SERVICE INFORMATION

Number: 644-1567

Topping up with power steering fluid

All 1994 and later Saab 900 models.

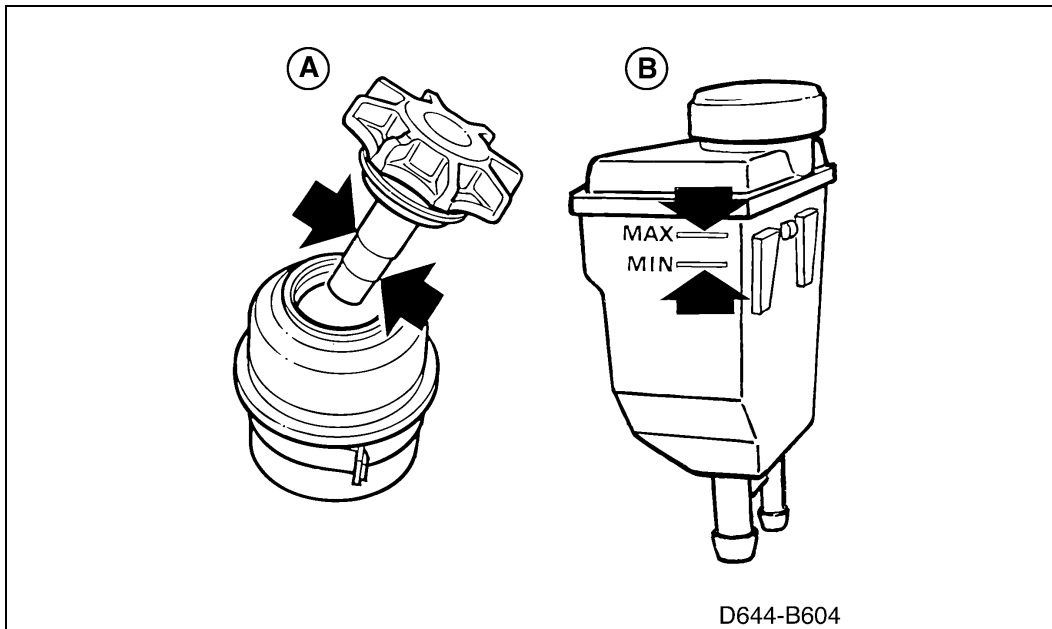
Power steering fluid has leaked out of the fluid reservoir in certain cases. This has happened in conditions of high temperature and at full lock. To avoid such leakage, the directions in this SI should be followed when topping up with power steering fluid.

- 1 Make sure that temperature of the fluid in the power steering system is about +20°C.
- 2 Turn the front wheels to the straight ahead position.
- 3 Check the fluid level. In this position it should be midway between the MAX and MIN marks on the dipstick fitted to the screw cap of the power steering fluid reservoir (A). On cars equipped with the Sensonic system, the marks are on the power steering fluid reservoir itself (B).
